June 27, 2019

**BOARD OF COUNTY COMMISSIONERS  
ORANGE COUNTY, FLORIDA  
IFB NO. Y19-767-TA/ ADDENDUM NO. 2**

**FORCE MAIN SOUTH AREA PACKAGE 2**

SCALE: AS SHOWN  
DRAWING NO.: C-100  
SHEET: 8 OF 17

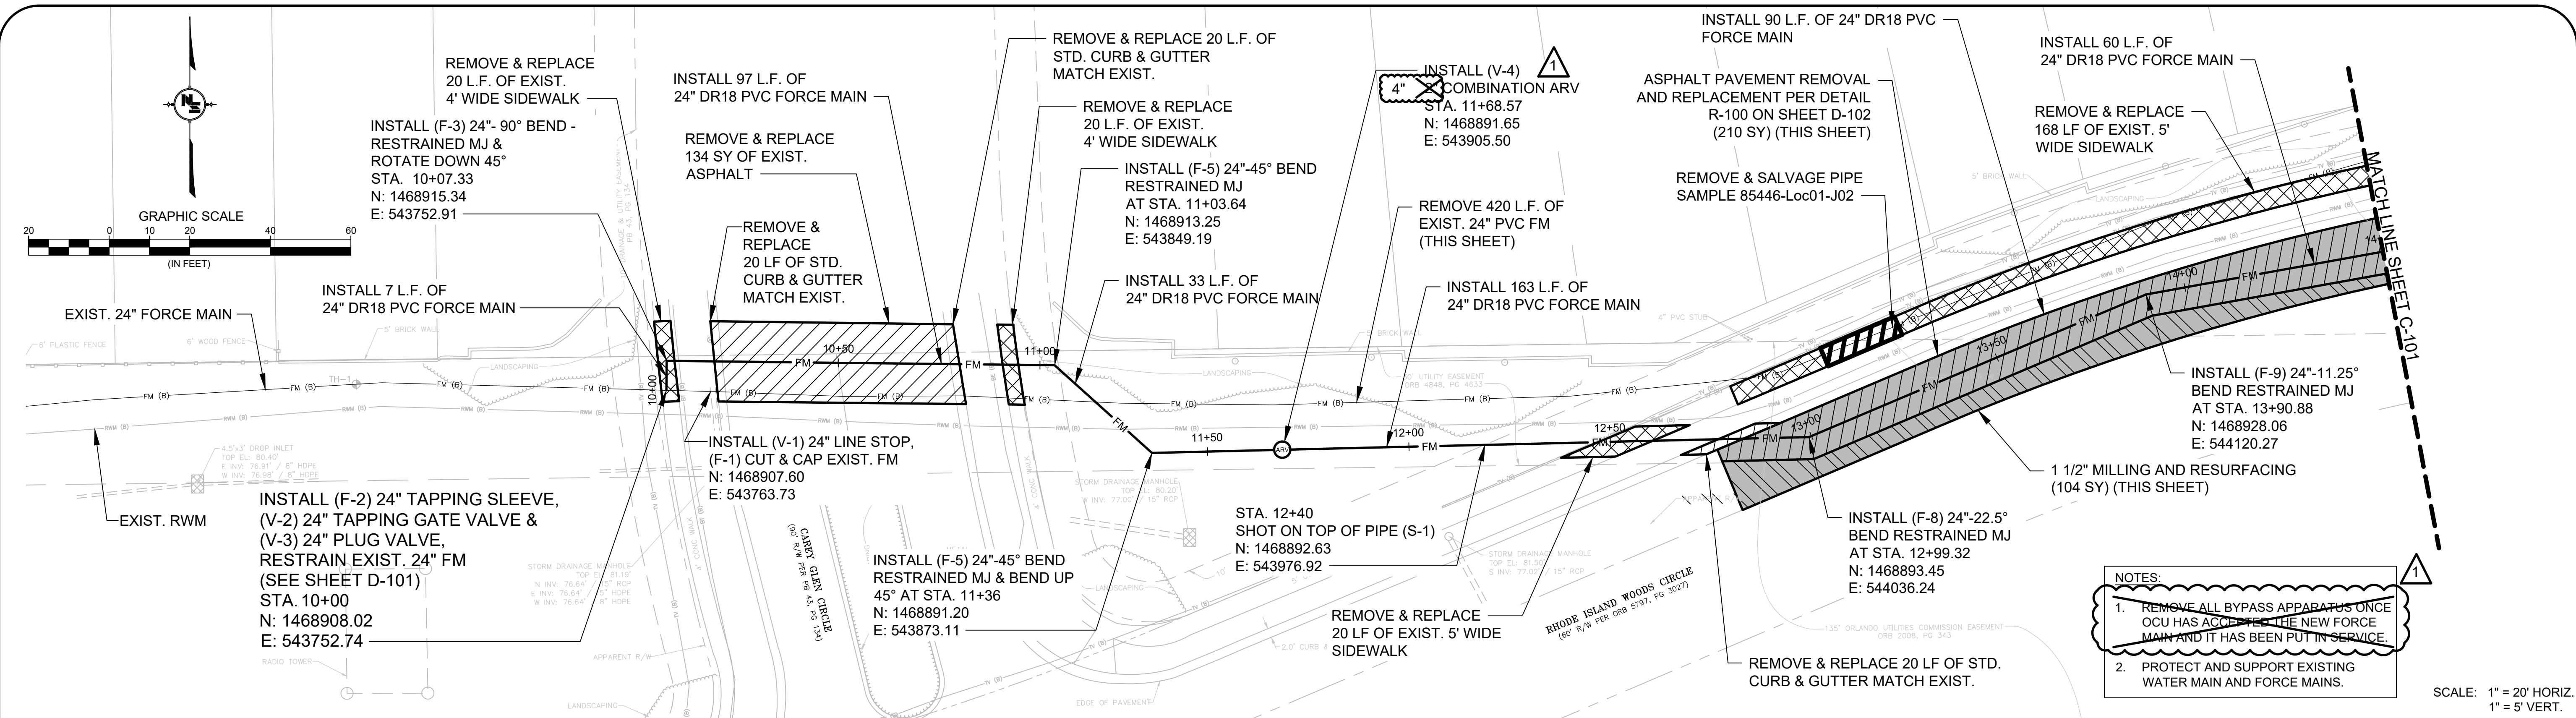
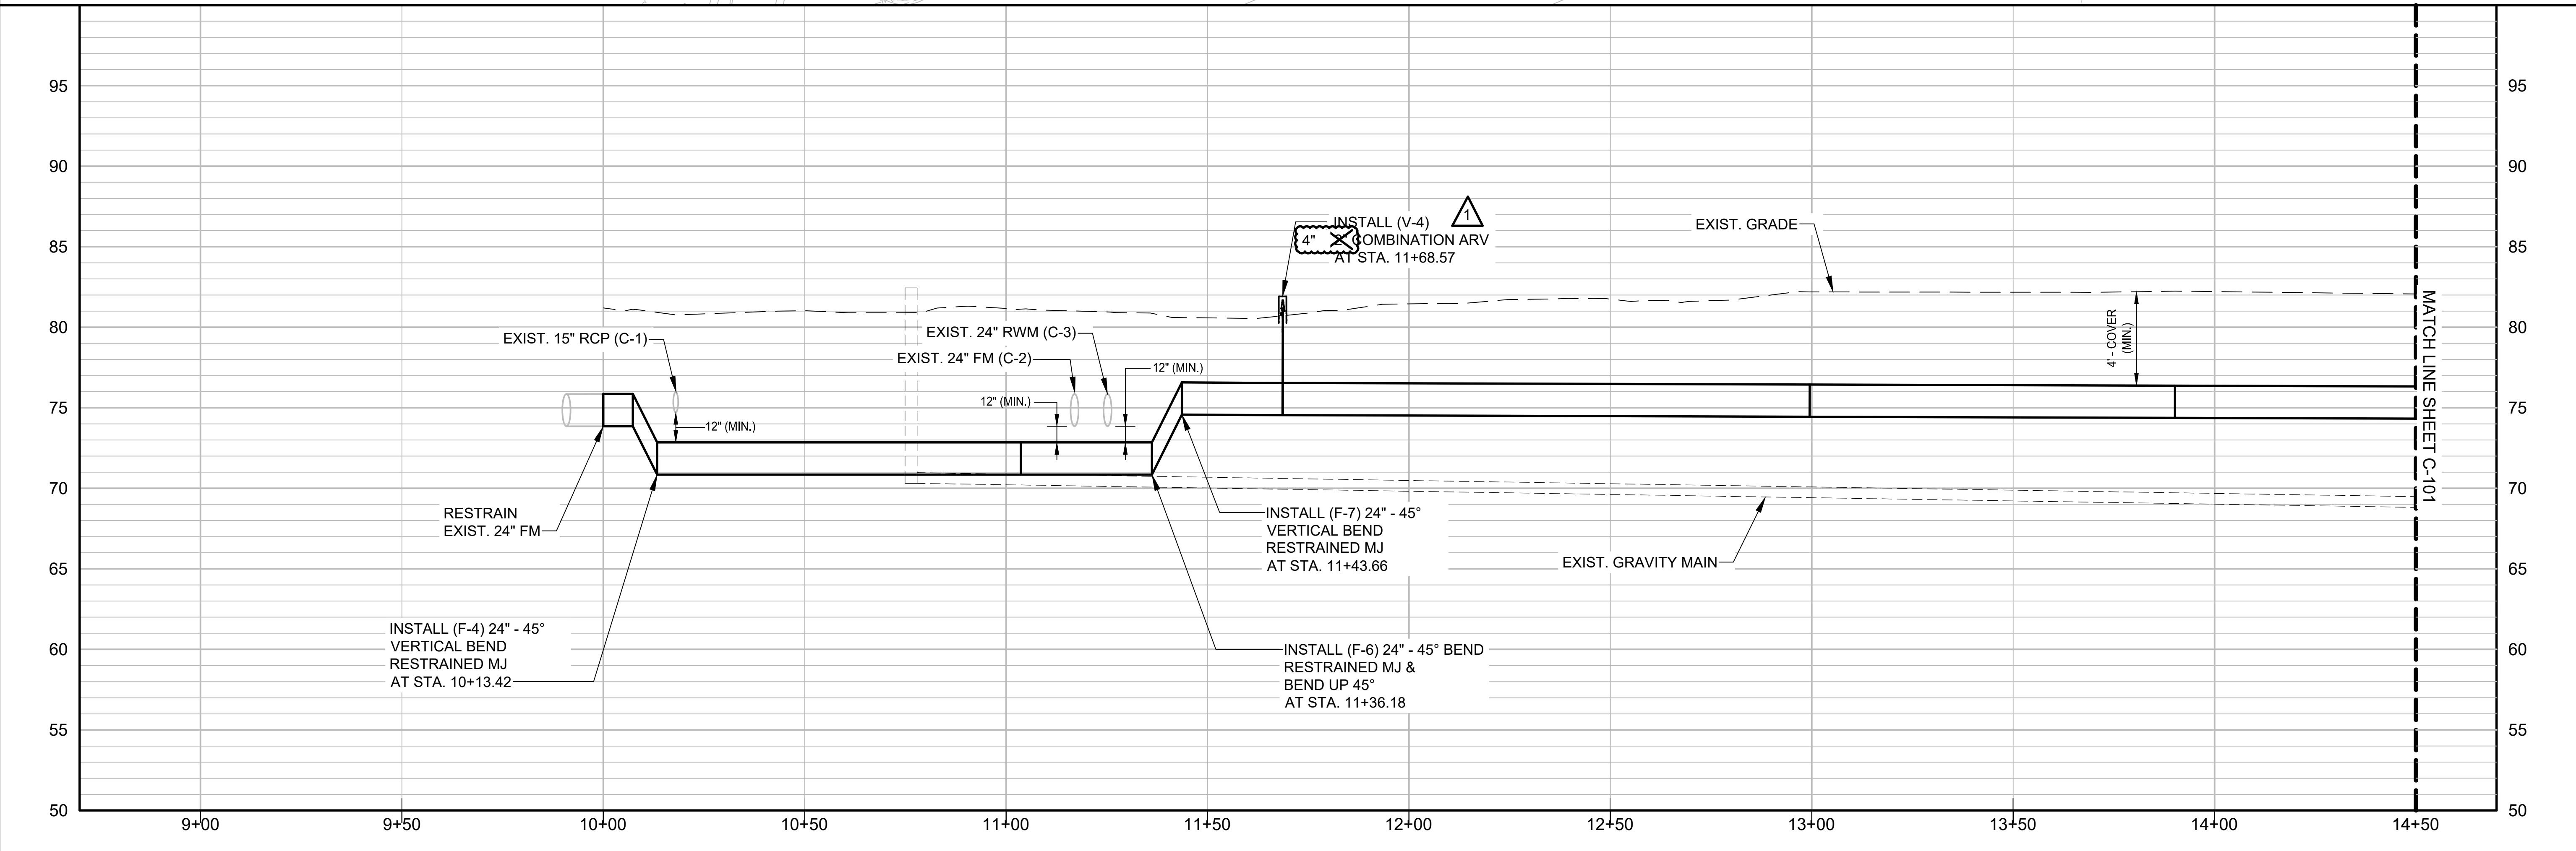
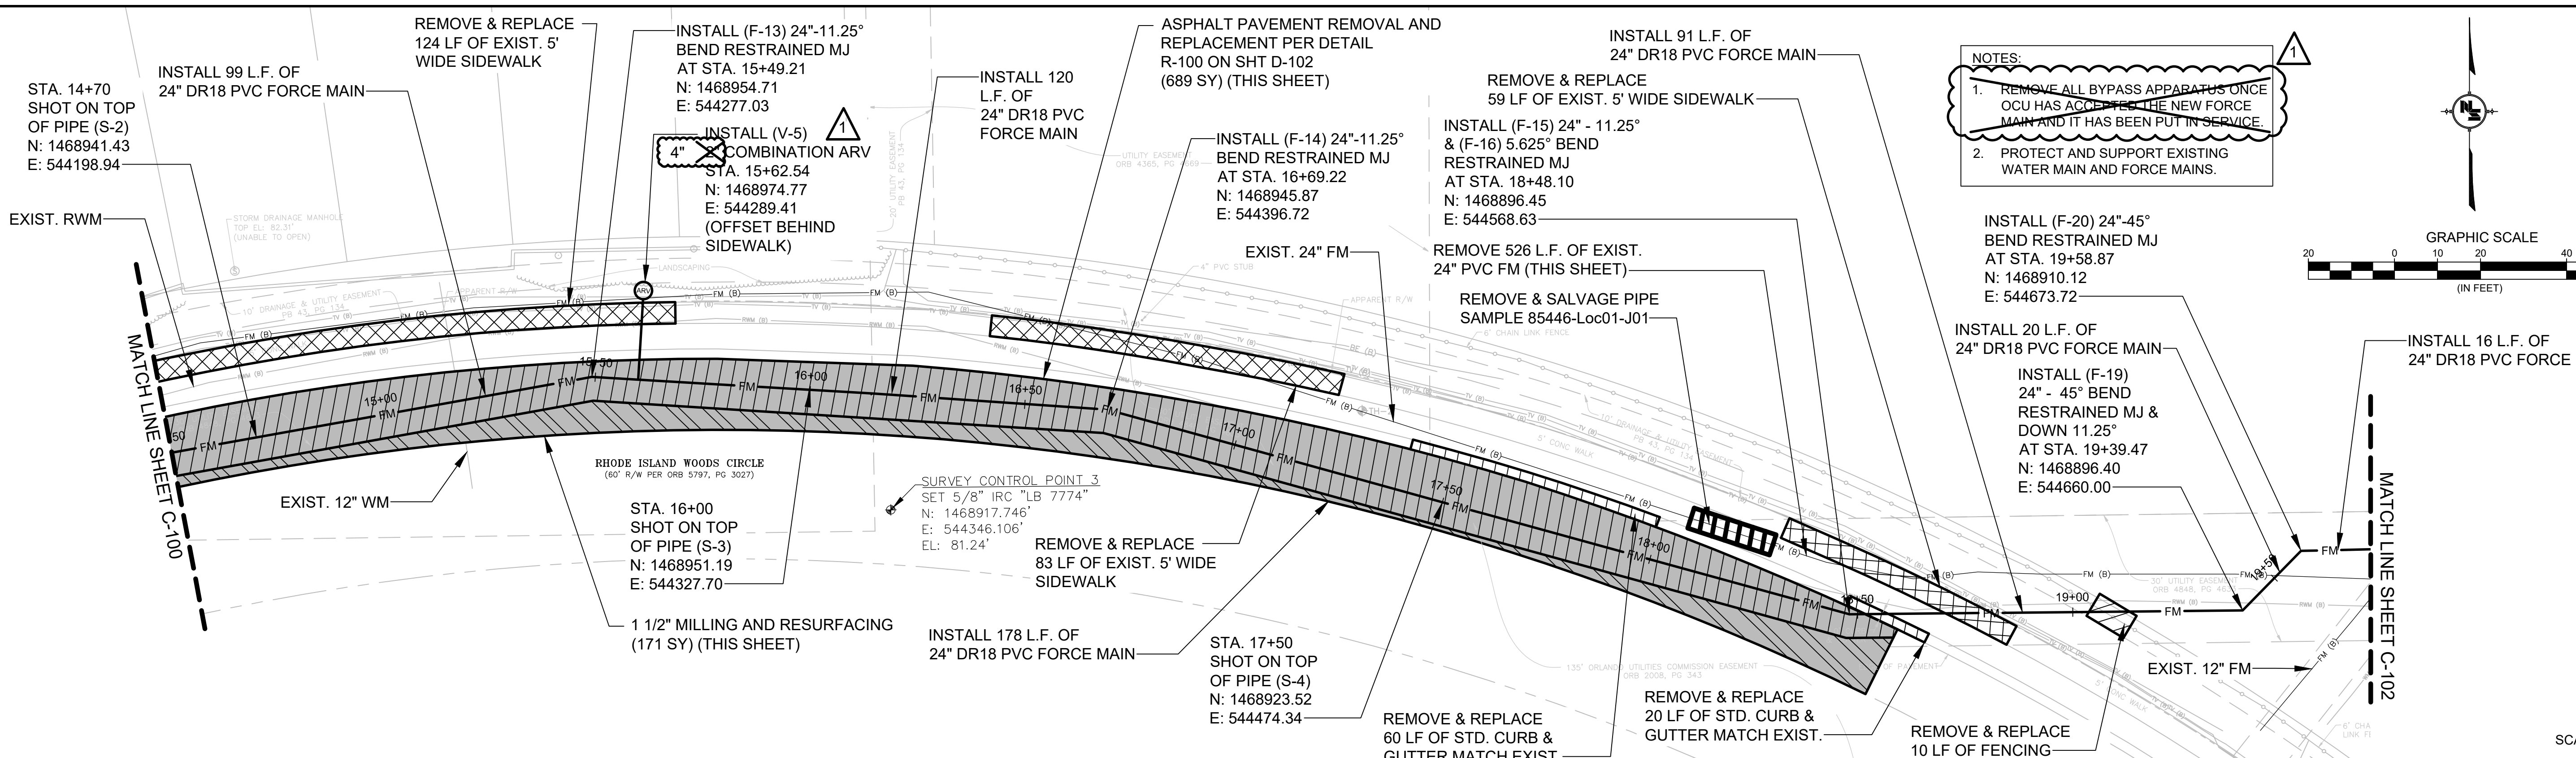
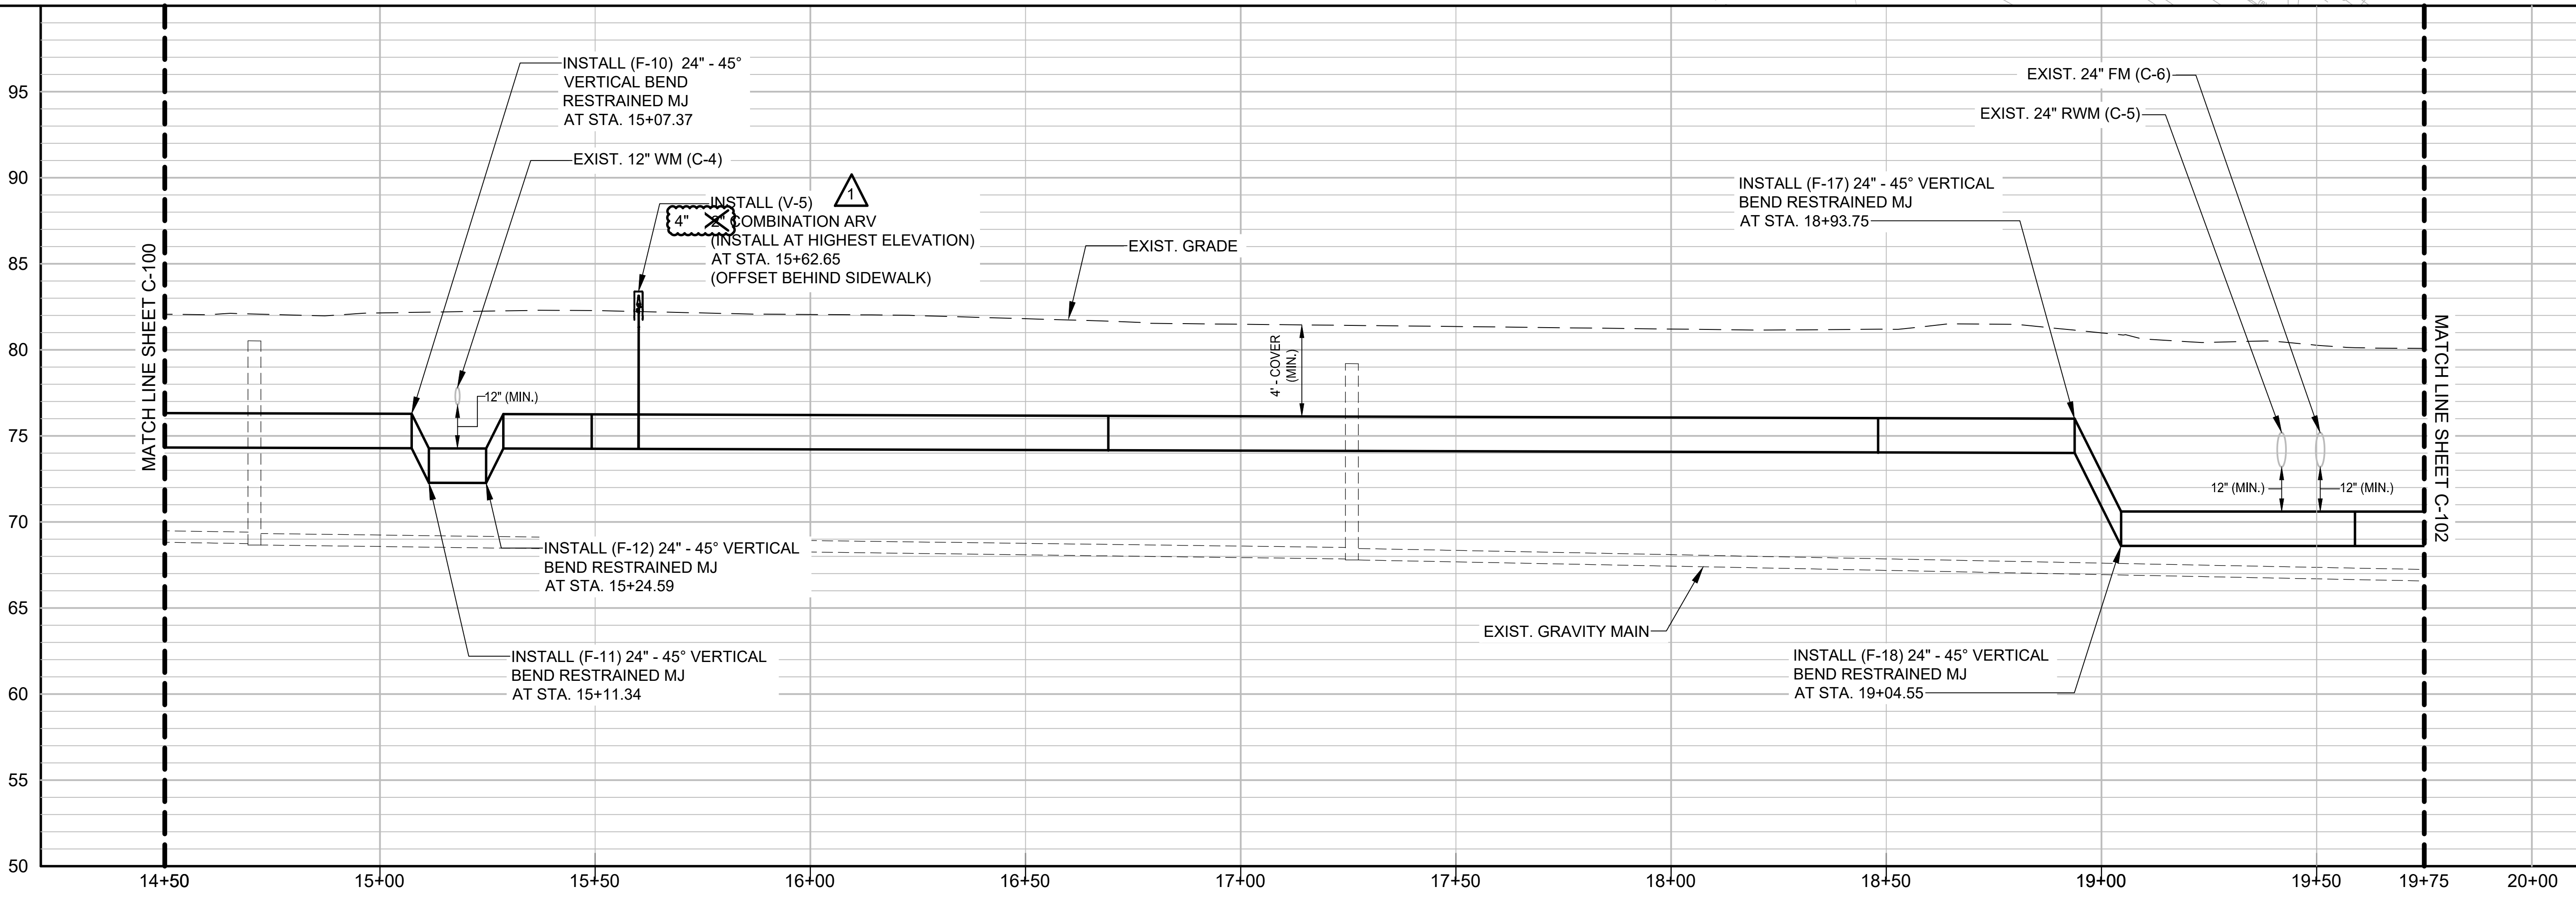
A: Bypass note has been deleted from sheets C100-C102 and C200-C201

- a. **Removal of Bypass note on sheets C-100, C-101, C-102, C-200 and C-201.**
- b. **Revision of ARV size on sheets C-100, C-101 and C-102.**
- c. **Revision of valve size V-13 on sheet X-100.**
